Amended Response to Request for Additional Information  
No.107-1293 Revision 0

**US-APWR Design Certification  
Mitsubshl Heavy Industries  
Docket No. 52-021**

**RAI NO.:** NO. 107-1293 REVISION 0  
**SRP SECTION:** 03.09.04 – CONTROL ROD DRIVE SYSTEMS  
**APPLICATION SECTION:** 3.9.4  
**DATE OF RAI ISSUE:** 11/24/08

**US-APWR Design Certification- 03.09.04, Control Rod Drive Systems (CRDS)**  
[Review performed against revision 0 of the US-APWR DCD Tier 2.]

Figure 1 Applied Area of the Chrome Carbide Coating

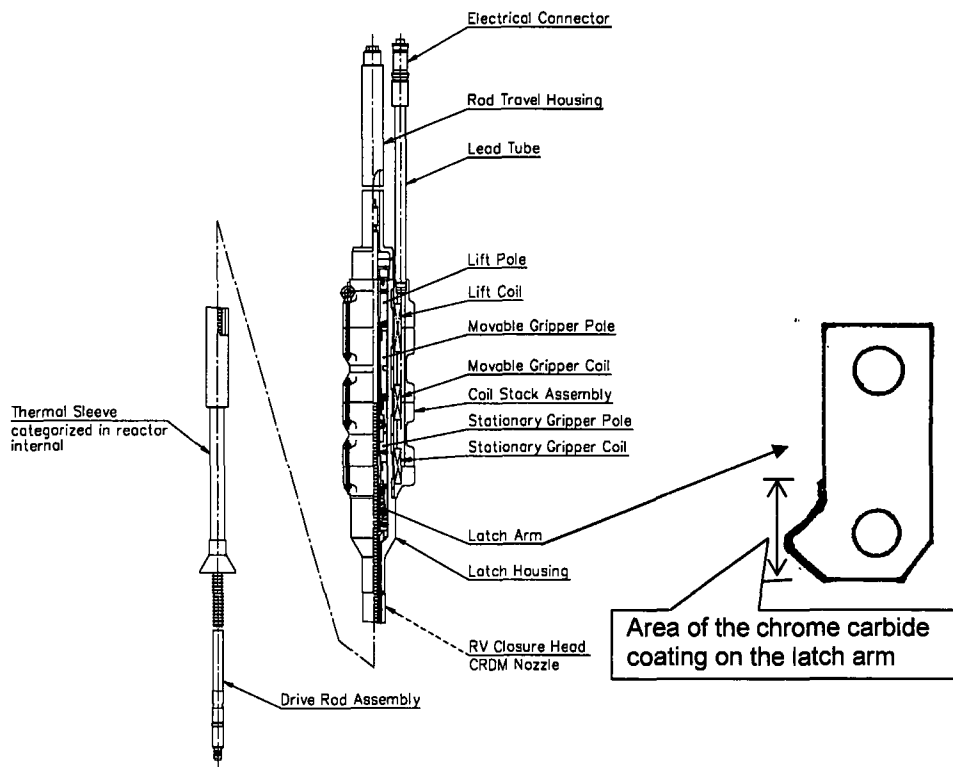
- a. Describe differences between the US-APWR and the previous design, such as the L-106A CRDM and discuss their effects on the applicability of the previous operability tests to the US-APWR CRDM. US-APWR DCD Tier 2, Section 3.9.4.1.1 (page 3.9-56) states that the US-APWR CRDM design is improved by (1) butt welding the CRDM latch housing to the CRDM nozzle on the reactor vessel closure head and (2) applying a chrome carbide coating to the latch arms.

The design of the US-APWR CRDM latch assembly is the same as the previous L-106A type CRDM, except the chrome carbide coating on the latch arms to improve wear resistance. The latch assembly is shown in Figure 1. This design change does not affect operability, since the thickness of the chrome carbide coating is thin enough compared with the clearance between the latch tip and the groove of the drive rod.

Thickness of the chrome carbide coating on the latch arm is [ ] mils, which is thin enough compared with the approximately [ ] in clearance between the latch tip and groove of the drive rod. Therefore, chrome carbide coating does not affect operability.

**Figure A-1 General Configuration of the US-APWR Control Rod Drive Mechanism**

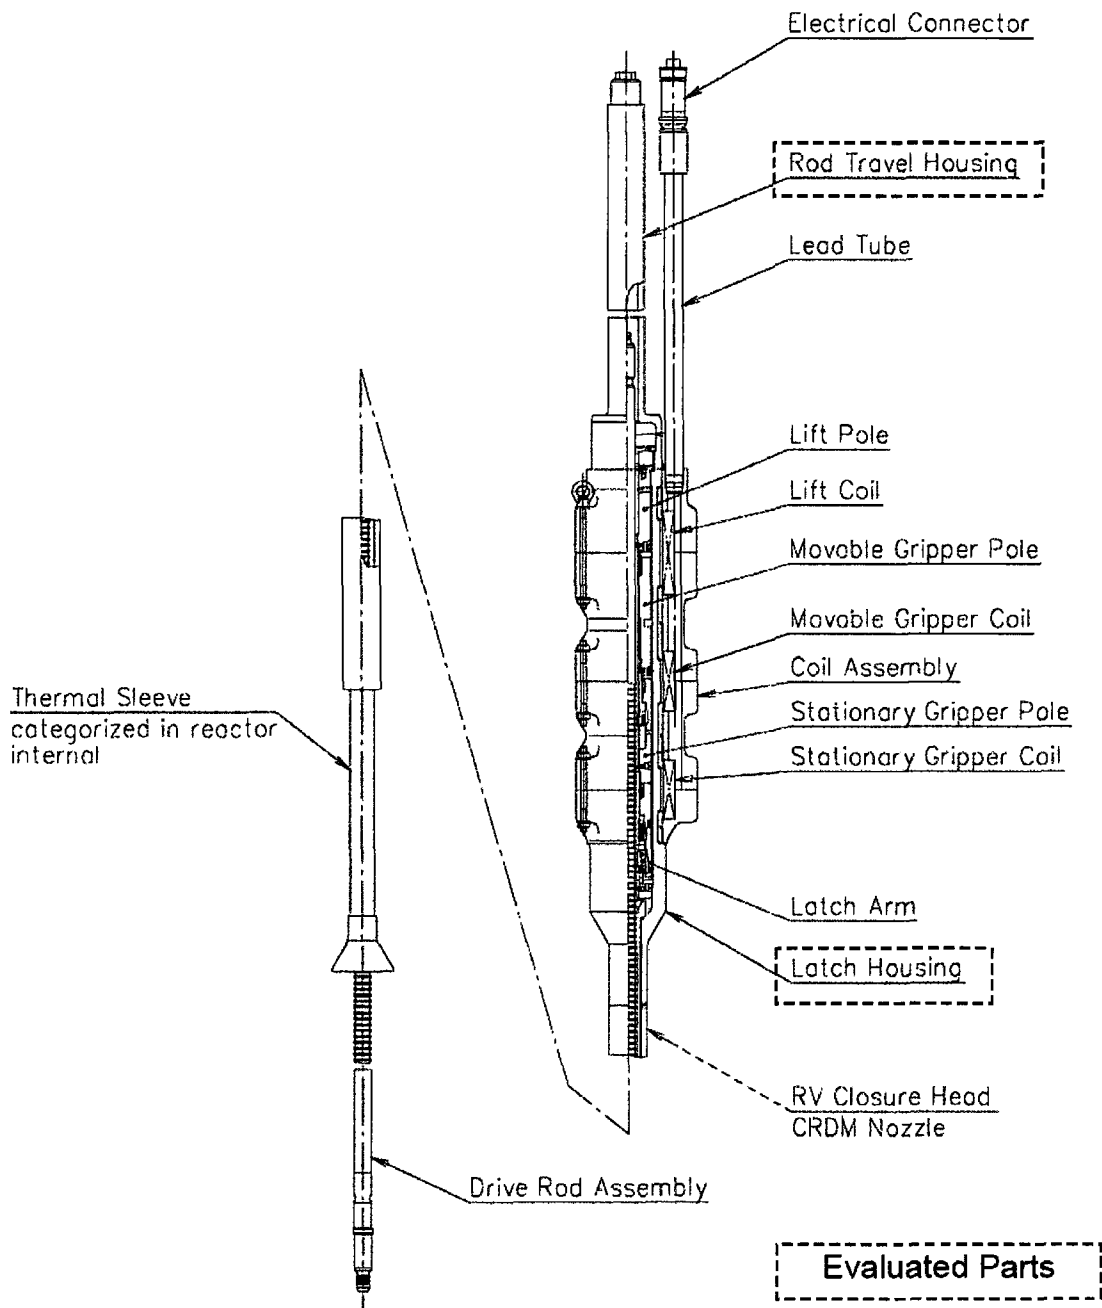
c. Compare the design LOCA plus SSE loads for the US-APWR CRDS to the loads that were used in the previous design verification tests.

The CRDM is a vertical cylindrical vessel with hemispherical top head. The CRDM is welded to the CRDM nozzle on the Reactor Vessel Closure Head (RVCH). Figure A-1 shows the general configuration of the US-APWR CRDM.

Figure-1 Test Equipment

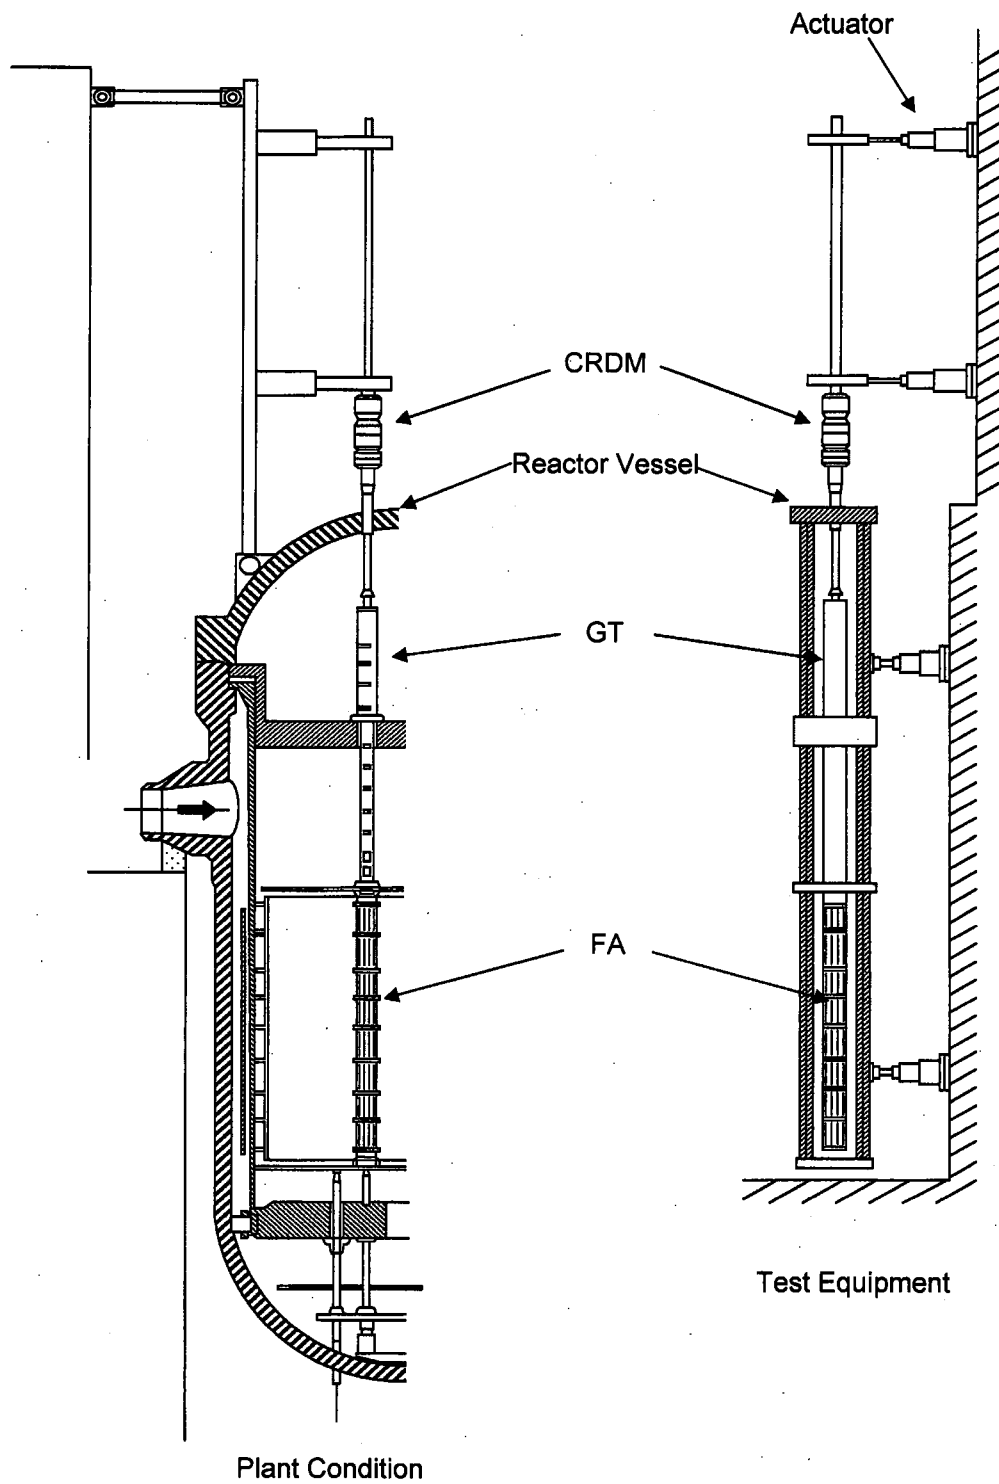
Provide for review the basis of the 1.18 in allowable rod travel housing deflection during the seismic event in US-APWR DCD Tier 2, Section 3.9.4.3 (page 3.9-62), and how it has been quantified by analysis that the rod control cluster assembly (RCCA) will be inserted into the core at this deflection.

Figure-1 shows the rod drop test model of drive-line components in a single channel, the L-106A type CRDM, the rod control cluster assembly guide tube (hereinafter called GT) and the fuel assembly (hereinafter called FA) for 17 x 17 type 12-ft plants. Also shown for comparison are the 14-ft fuel assembly drive-line plant conditions. The test modeling conditions are shown in Table-1. For the test models, the same scale and material of the CRDM and GT as actual plant were used. In addition, the same scale and material of the RCCA and FA as actual plant were applied except to use the alternate materials with the equal weight for the absorber in the RCCA and the Uranium in the FA.

Test equipment is shown in Figure-2. The GT and FA were placed in a test vessel with support plates corresponding to an upper core support plate, an upper core plate and a lower core plate. In addition, CRDM was placed on the test vessel, and their interior (in the test vessel and the CRDM) was filled with the water.
